## **REMARKS**

### **I. Objection to Drawings**

**FIG. 8**  
**PAGER**

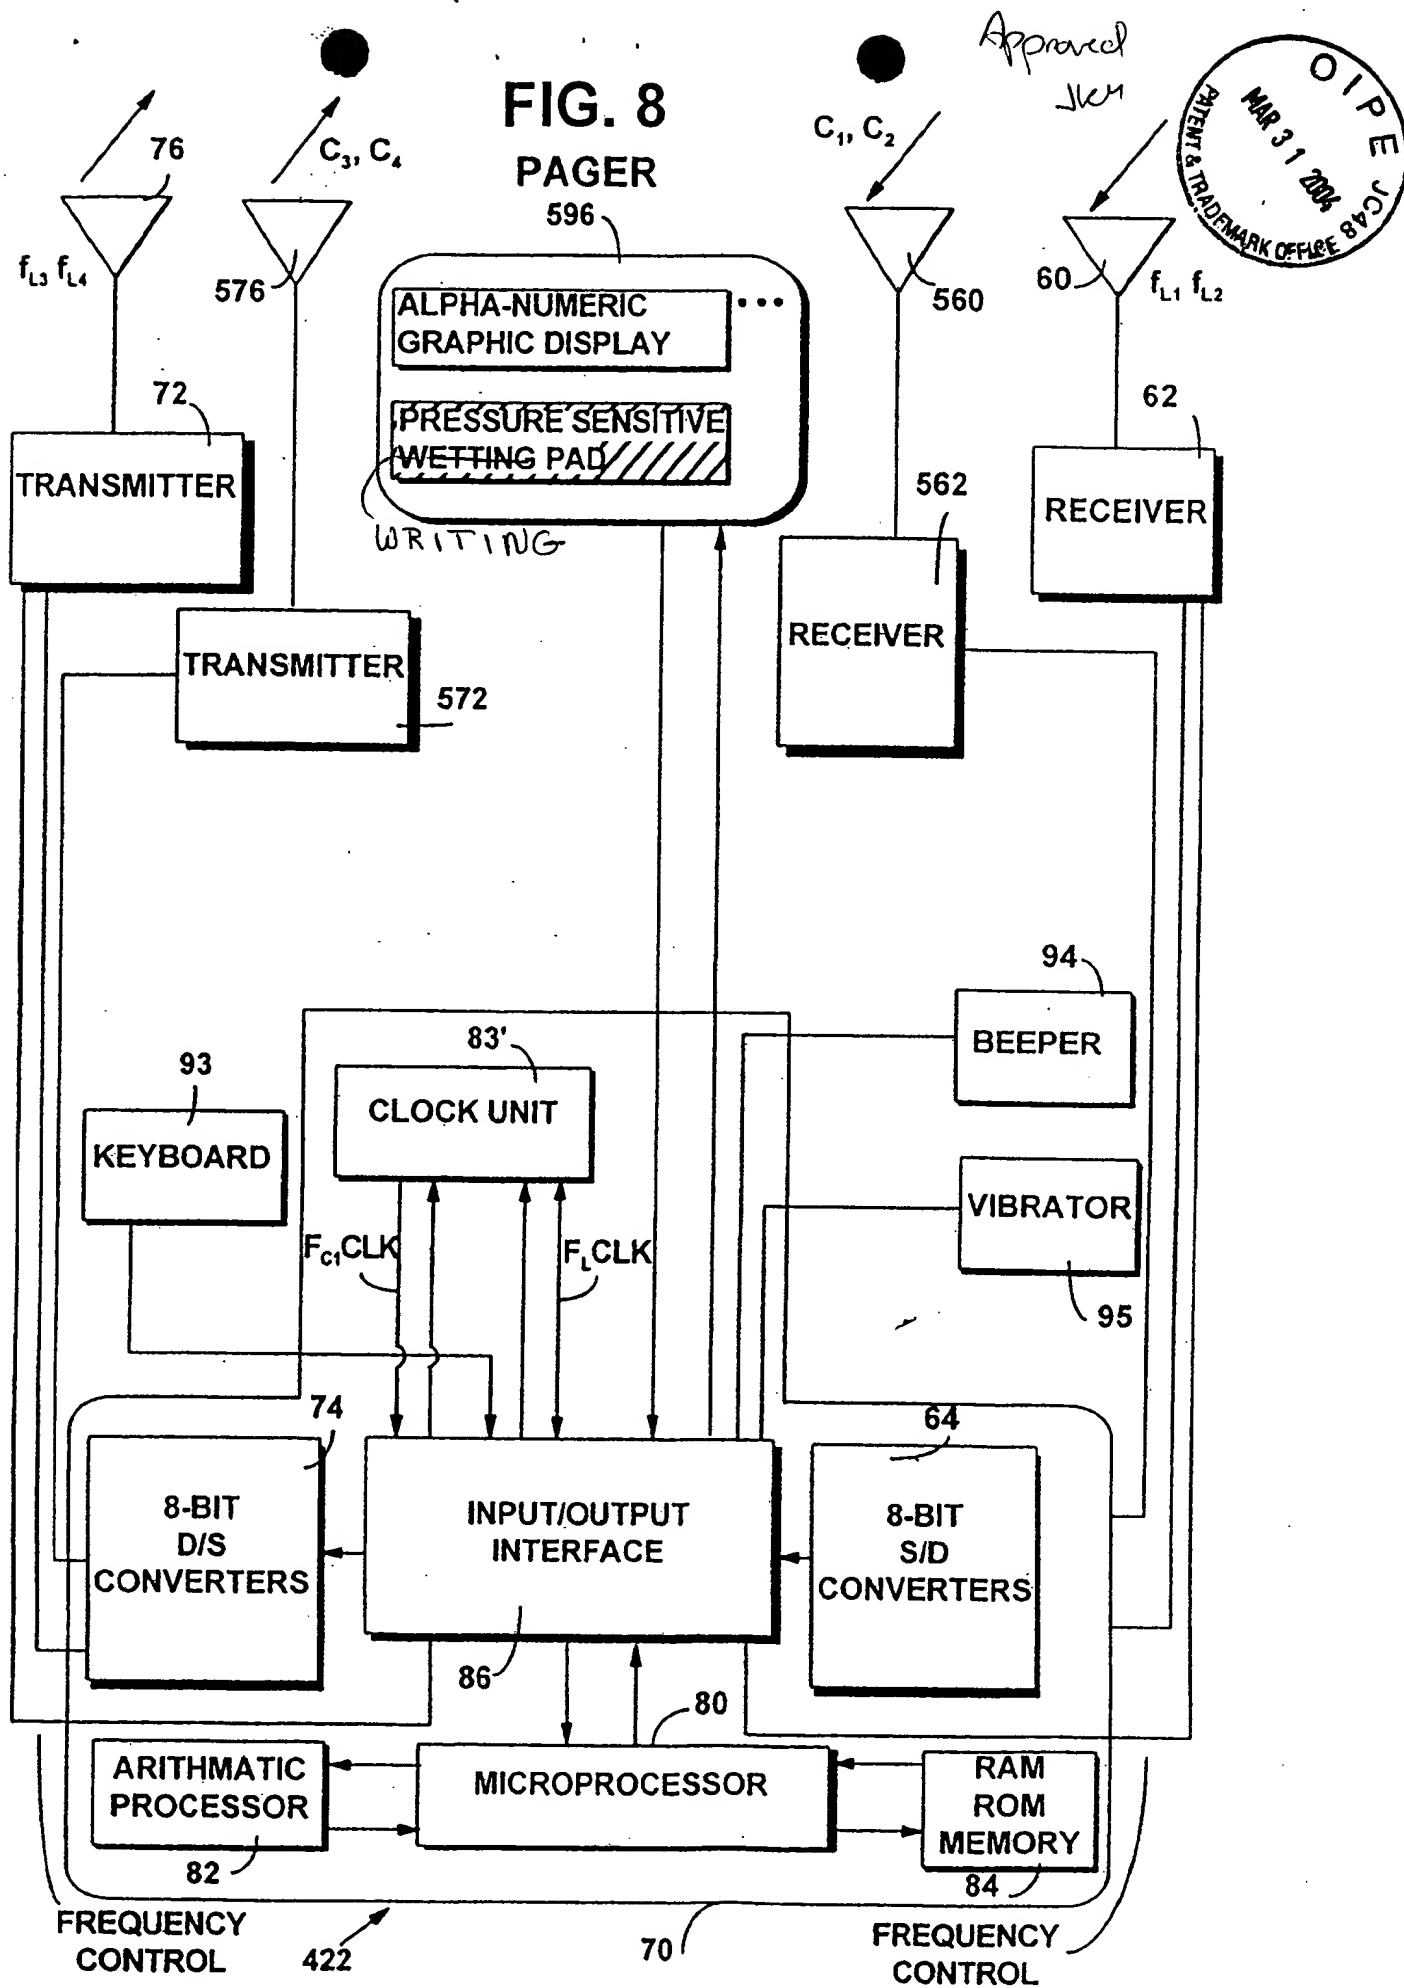
In Fig. 8, box 596, "WETTING" should be changed to "WRITING".

In response, Applicants have amended the drawings as requested. Accordingly, Applicants request that the drawing objections be withdrawn.
